DisplayHDR CTS v1.0 Errata E3 Published 02/12/19

This errata contains all SCRs published through 2/12/19.

- Refinement of the DPM Rise Time Performance Test
- Correction of the DisplayHDR CTS, Appendix Table B-3
- DHDR_CTS_10%_patch_screen_saver_SCR v0.9
- DHDR_CTS_Add_True_Black_Level_SCR v0.92
- Updates to recommended test tool location & OS versions
- Introduction of the new 500 level to the DisplayHDR CTS
- DisplayHDR_Mode_Indicator_SCR
- DisplayHDR_DP_Certification_Requirement_SCR

5.1.1 Minimum-white Luminance – 10% Center Patch Test

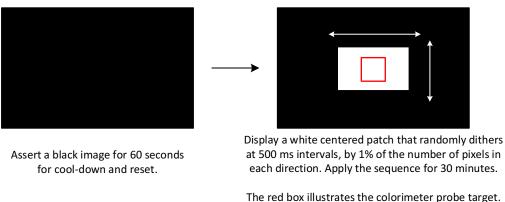
Replace section 5.1.1 with the following section

Replace Figure 5-1 with the above.

- Black video signal is provided for 60 seconds, code value 0. Actual backlight power would thus be determined by scaler/TCON/GPU.
- Bright white, code value 1023. Center Patch test is assumed to reach "steady state," from a power delivery and thermal perspective, within 30 minutes. Thus, there is no need to repeat the test more than once.
- A sequence of bright white, code value 1023, patches. The patch location shall be static for 500 ms and shift randomly in around the center with a uniform pseudorandom value. A constant random seed shall be used to obtain the same random sequence whenever the pattern starts.
- The actual code used for the motion path is defined in Appendix B.1

- Luminance is measured at the screen's center once per minute for 30 measurements, over 30 minutes, using the same panel. The first measurement should be obtained within 5 seconds of when the **white** box begins to display. The red box in Figure 5-4 is only illustrative.
- All 30 measurements must be measured at a level that is higher than the Minimum Required Luminance specified in Table 5-2.
